**Re:** Second Submission Review – Avelon – Framework Development Plan and Comprehensive Plan Amendment  
**Application Number:** DA-2121-00  
**Case Numbers:** 2018-1002-00; 2018-7004-00

## Second Submission Review

**Avelon FDP -2ndRef - November 2018**

**AVELON MASTER DRAINAGE REPORT**

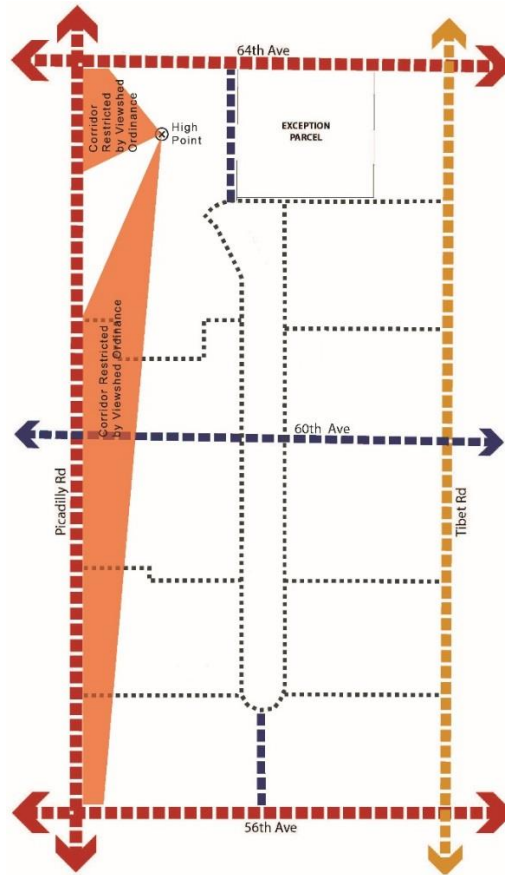
- A. FDP Narrative Statement: *“As has been discussed with City Staff, we believe that the results of the EPS study in this area are contradictory to the old view preservation ordinance that was approved in 1991 and restricts development of this critical corner. As a result, we have proposed a plan for this corner that maximizes the commercial development while largely meeting the intent of the ordinance.”*

PROS Response: PROS stands by the requirements established for land development at the high point, corner of Picadilly and 64<sup>th</sup> Avenue as mandated by [Section 146-885](#) and the High Point Park View Corridor Analysis. As an ordinance, these requirements may not be waived in consideration of alternative planning perspectives held by the applicant.

Exhibit 11: Park Boundary Prior to Study

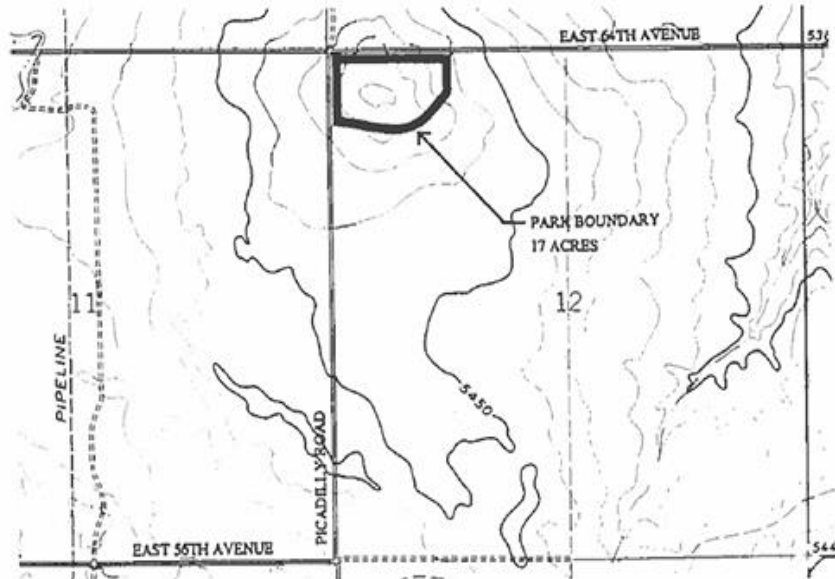
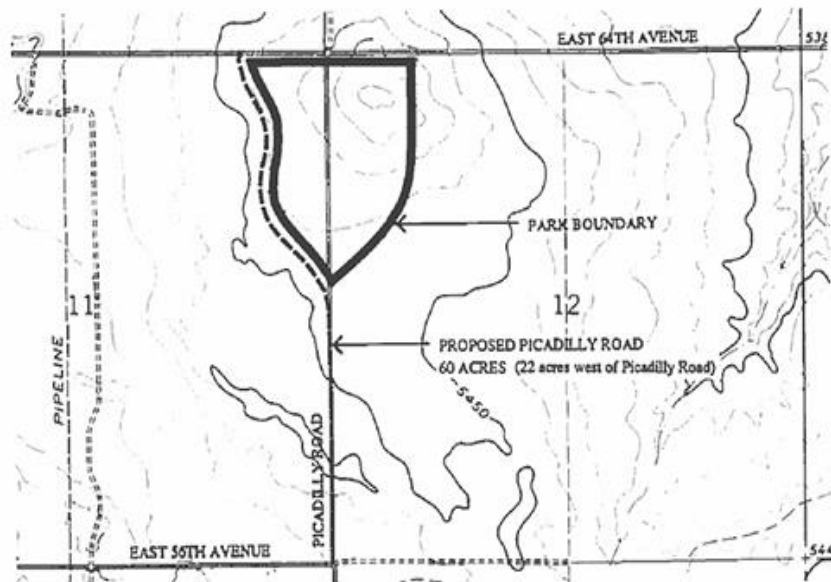
PROS Response: Relative to the clarity of the GDP concerning the term ‘public purposes’, the clause in Item 7, “*The property owners agree to dedicate the NW corner of Section 12 for public purposes in accordance with the Public Land Dedication requirements contained in the annexation agreement.*” ties the phrase ‘public purposes’ with the process of land dedication as defined in the 1991 Annexation Agreement. Precedent within the City of Aurora consistently interprets Public Land Dedication as lands dedicated to the City of Aurora as parks, open space, fire, police or library facilities. With the inclusion of the direction from the High Point Park View Corridor Analysis and [Section 146-885](#), it is clear that the only use applicable for the area in question a public park. Following extensive review, this position is supported by the City Attorney’s office. There is no precedent for interpreting the phrase ‘Public Land’ in annexation agreements as private retail, commercial, or entertainment development.

Regarding the size and location of the High Point Park referred to in multiple guidance documents, the legally accepted language comes from the Council approved January 1991 High Point Park View Corridor Analysis. The View Corridor Analysis is the fundamental document from which all other subject-specific guidance and [Section 146-885](#) were derived. The location of the High Point Park is the southeast corner of 64<sup>th</sup> Avenue and Picadilly Road intersection (northwest corner of subject property) encompassing the physical high point as it exists on the Avelon property today. The size of the High Point Park recommended by Exhibit 12 of the View Corridor Analysis clearly ranges between 17 acres and 60 acres. It is the continued direction of PROS for the applicant to dedicate a 20 acre community park consistent with all supporting/guiding documentation mentioned previously and located at the northwest corner of 64<sup>th</sup> Avenue and Picadilly Road.

**BASIN MAP FUTURE**

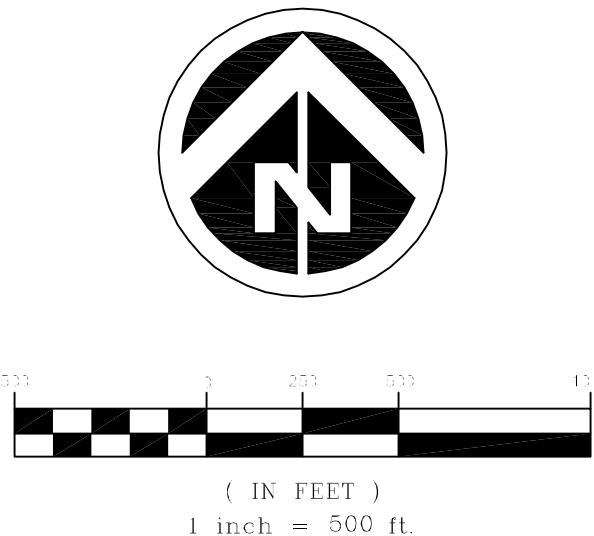
Shows up as 35.2 ac-ft elsewhere

Is this supposed to be an 8'x6' RCB?
